**Re: Section 16 Planning Application for Proposed Temporary Public Vehicle Park for Private Cars and Light Goods Vehicles with Ancillary Electric Vehicle Charging Facilities for a Period of 3 Years at Lot Nos. 1018 RP (Part), 1019 RP (Part), 1022 RP (Part), 1020 (Part), 1021 (Part) and 1024 (Part) in D.D. 121, Tong Yan San Tsuen, Yuen Long, New Territories
(Planning Application No. A/YL-TYST/1374)**

Response to Comment Table

Drainage Proposal - LAYOUT

Existing Drainage Pipes and Manhole Facilities (Extract of the GeoInfo Map)

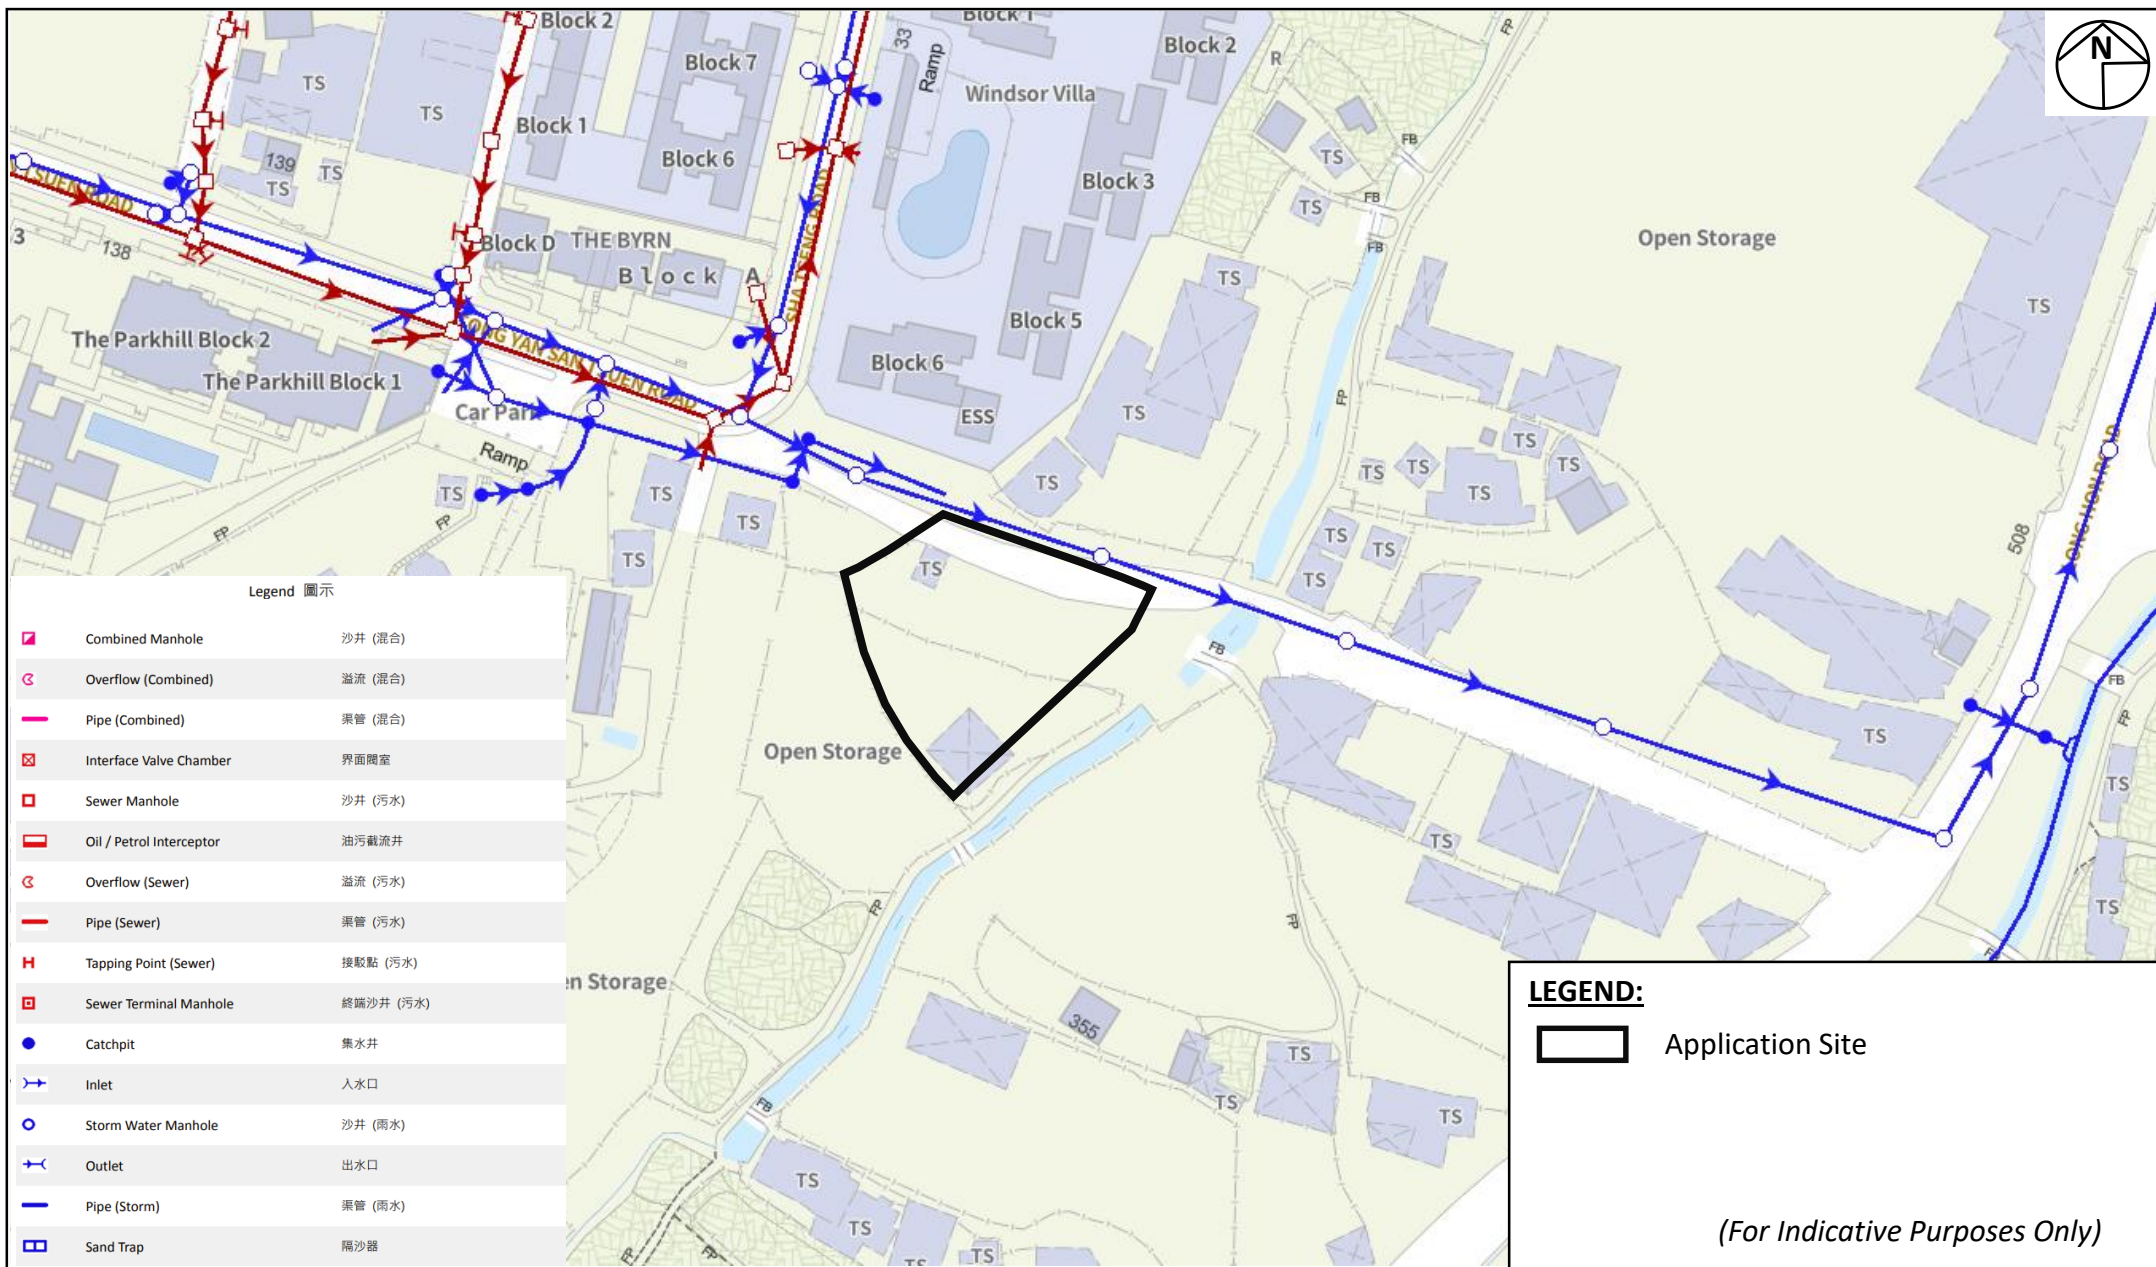
Comment from the Drainage Services Department (8.10.2026)	Response
It is noted the application site would encroach upon an existing access road on its northern site and this access road will be realigned further north into the existing verge area according to Figure 1 of the planning statement. The proposed realignment would affect the existing drains (serving the upstream private developments, including Planning Application No. A/YL-TYST/1351) and the existing trees located north of the existing access road. The relevant government departments and stakeholders should be consulted on the applicant's proposed works; Further to the above comment from public drainage point of view, the applicant should submit a drainage proposal demonstrating a feasible diversion scheme for the existing drains for our agreement and such diversion works should be carried out by the applicant at his own expense. The existing drainage facilities should not be disturbed or interfered with until any necessary diversion works, which have been accepted by DSD and the relevant stakeholders, have been satisfactorily completed. The applicant may refer to the GeoInfo Map (http://www.map.gov.hk/gm/) to obtain records of nearby public drainage pipes and manhole facilities.	The application site encompasses private lots only and access road will be realigned further north. A site inspection was carried out on 12.10.2026. Photos 3 and 9 of the drainage proposal show the existing condition at the proposed road realignment location and no U-channels were found to the north of the application site. As refer to the drainage proposal, the proposed development does not encroach upon the existing 1.5m pipe, and would not affect the existing drains serving the upstream private developments. The applicant will consult relevant government departments for the proposed works. Noted. Please refer to the drainage proposal. Based on current site conditions, no existing U-channel is found to the north of the application site. As shown in the drainage proposal, the proposed works will not affect existing drainage facilities. Consequently, no diversion works are required, and the proposed development will not affect existing drains. The applicant is committed to implementing the drainage works to the satisfaction of DSD by way of approval conditions. Noted. With reference to Figure 5 and the drainage proposal, no existing U-channel is found to the north of the application site, and the proposed

Comment from the Drainage Services Department (8.10.2026)	Response
The applicant should verify the existence of any drains/sewers/utilities and also their exact locations, levels, and alignments on site in order to ascertain the positions and levels of the proposed manholes and the associated connection works. The development should neither obstruct overland flow nor adversely affect existing natural streams, village drains, ditches and the adjacent areas, etc.	development will not affect nearby public drainage pipes or manhole facilities. The applicant is committed to implementing the drainage works to the satisfaction of DSD by way of approval conditions. Noted.
